**TOWN OF NEWBURGH
PLANNING BOARD
TECHNICAL REVIEW COMMENTS**

PROJECT: DIXON 2 LOT SUBDIVISION
PROJECT NO.: 14-15
PROJECT LOCATION: SECTION 3, BLOCK 1, LOT 103.31
PROJECT REPRESENTATIVE: TALCOTT ENGINEERING
REVIEW DATE: 13 NOVEMBER 2014
MEETING DATE: 20 NOVEMBER 2014

Re: Dixon 2 Lot Subdivision
Town Project No. 2014-15
S-B-L: 3-1-103.31
Job No. 13074-PEI

LOT LAYOUT
PROPOSED SUBDIVISION ENTITLED "DIXON SUBDIVISION II"
85 FOREST ROAD (COUNTY RT 23)
SBL 3-1-103.31, LOT #3 FM#42-94
TOWN OF NEWBURGH, ORANGE COUNTY, NY

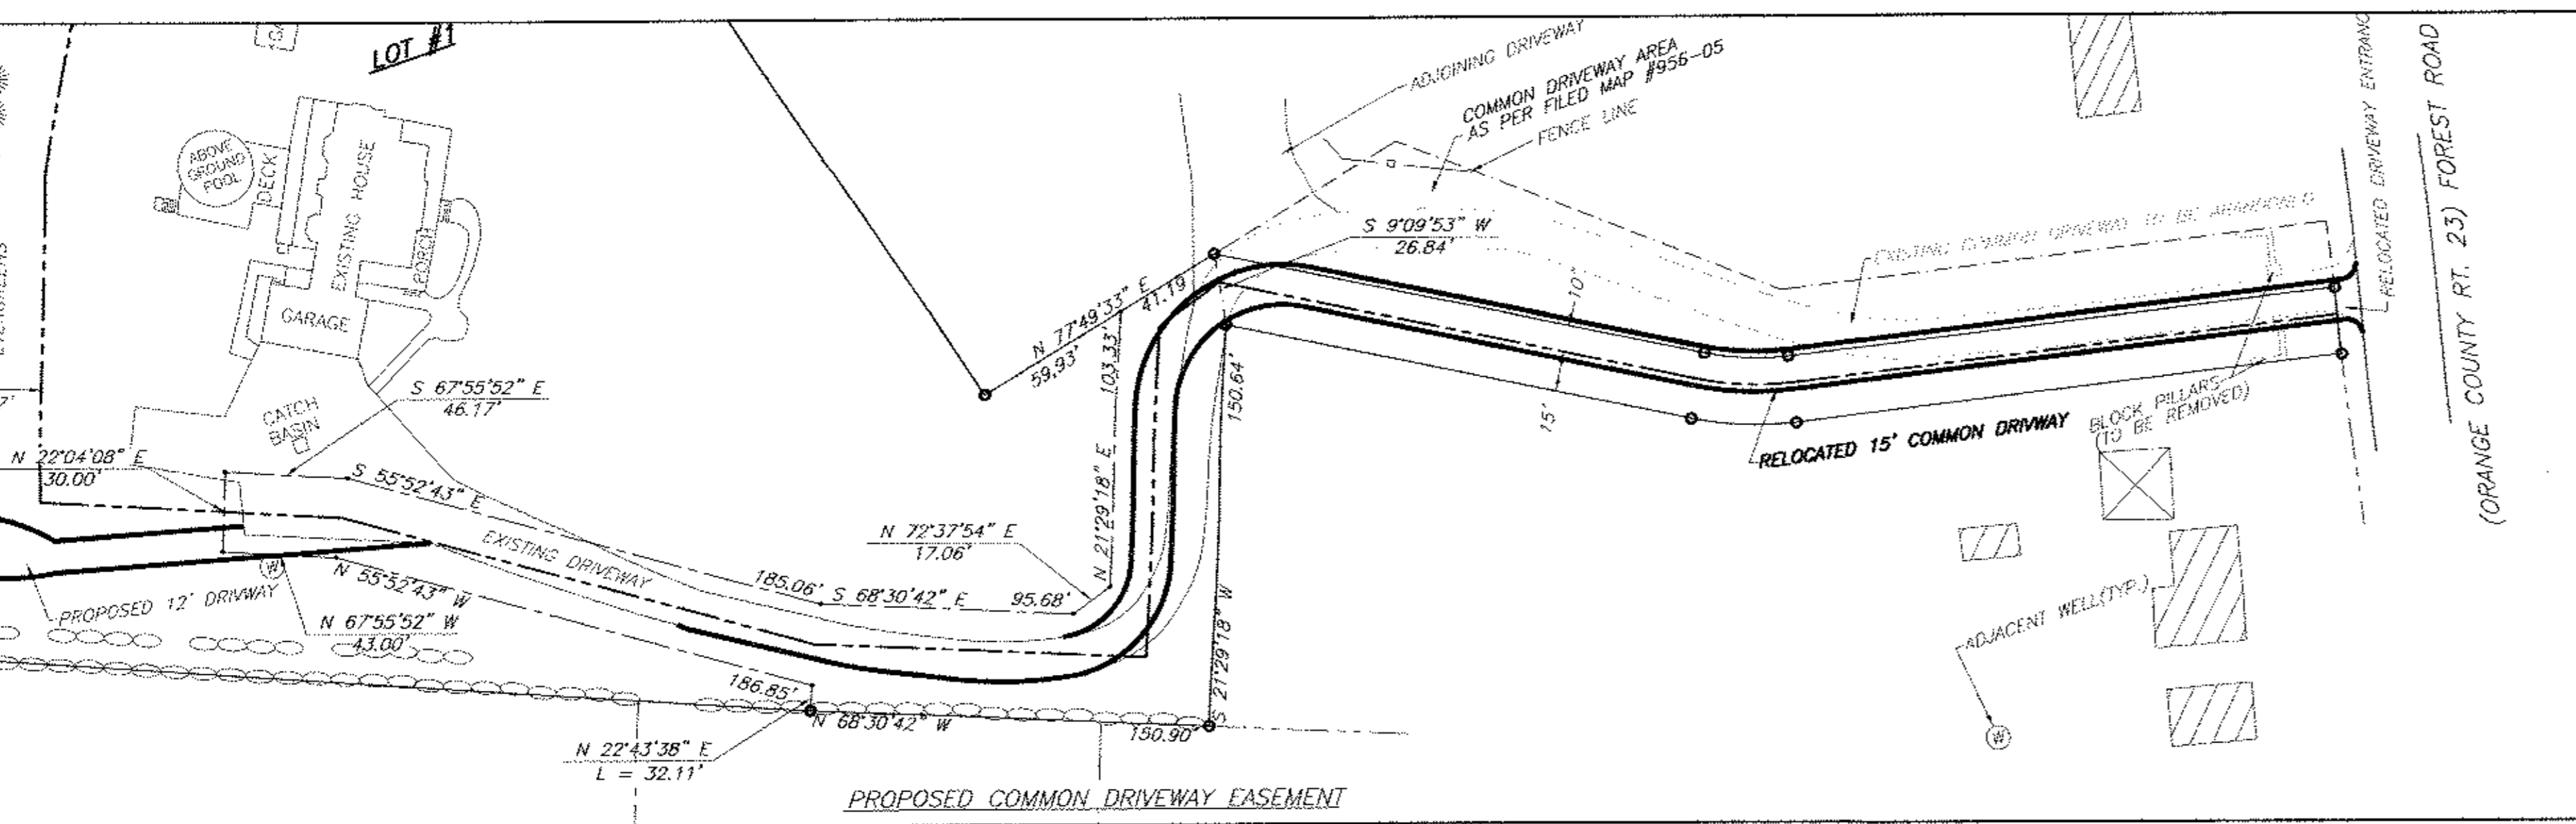
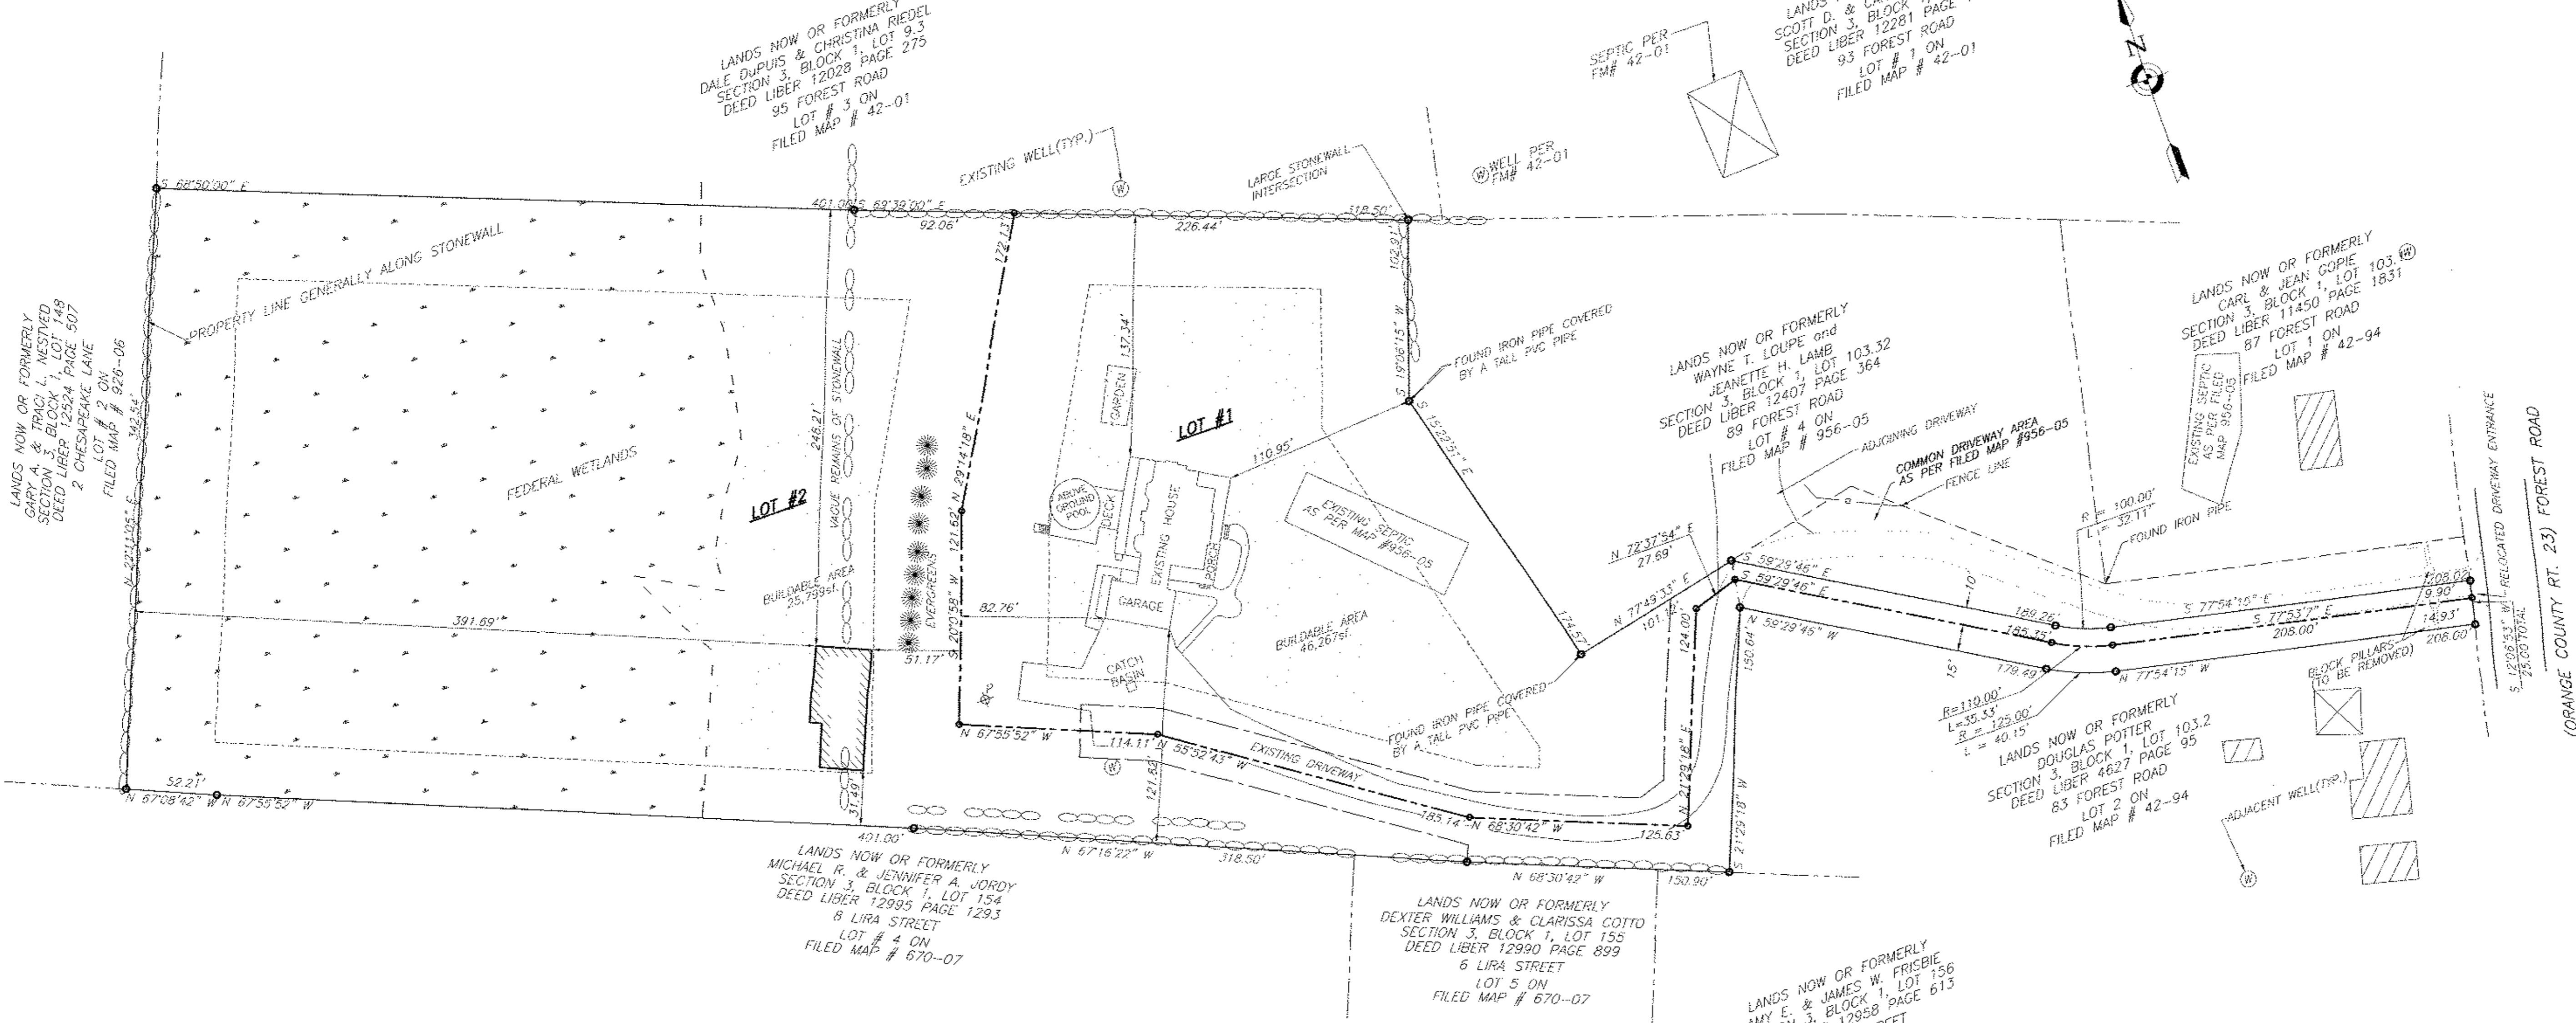
1. The proposed flag lot layout does not meet the requirements of access to a public highway as neither of the strips of land is 15 feet wide or wider. A 9.9 foot wide and a 14.93 foot wide which may actually narrow towards the proposed subdivision are identified on the plans.
2. A note will be added to the map requiring the installation of the new well to service existing structure on lot 1 prior to filing of the subdivision map.
3. Orange County DPW approval for the driveway is required.
4. Abandonment of the existing private driveway would apparently require concurrence of the Owners of lot 103.32.
5. Any approval which contains 3 lots on a private roadway would require the road to be named in accordance with the Town 911 system.

1. The driveway and proposed property lines have been relocated such that a portion of it is on each lot for the full length of "common driveway".

1. See Above
2. We are prepared to go before the Town Board for 3 lots on 1 common driveway.
3. A note has been added requiring the well for Lot 1 to be drilled prior to the filing of the subdivision.
